## **The London Resort**

Revised Parameter Study Update

October 2021

1.0
Gate 1
Parameter Evolution

Gate 1 - Lowest Strata with assumed 15m perimeter service zone

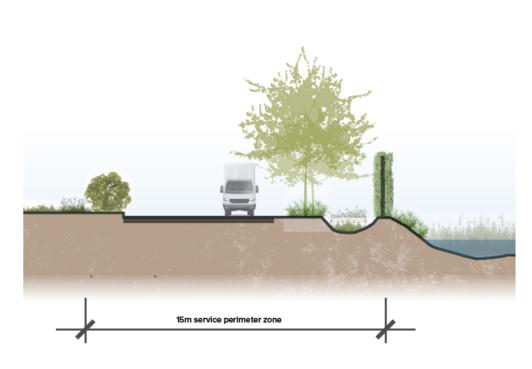
However, it was felt that the approach could be further refined by identifying how much of the massing would be filigree, lighter-weight 'ride' massing rather than the more traditional built form. This is especially important in the higher parts of the parameters where these taller elements have the potential to impact views more.

There was also a request for the team to look at refining the parameter of the lowest 'strata' of the parameter which had been left at 100%, when in fact the figure was likely to be lower once roads, streets and other open spaces including hard and soft landscaping were accounted for

We have therefore reduced the parameter for the lowest 'strata' from 100% to 80%..

This includes an assumption that there is a 15m wide zone around the perimeter which accommodates the service road, fencing, drainage, internal landscaping and modest ancillary buildings and as such won't be suitable for rides or buildings of significant scale in most instances.
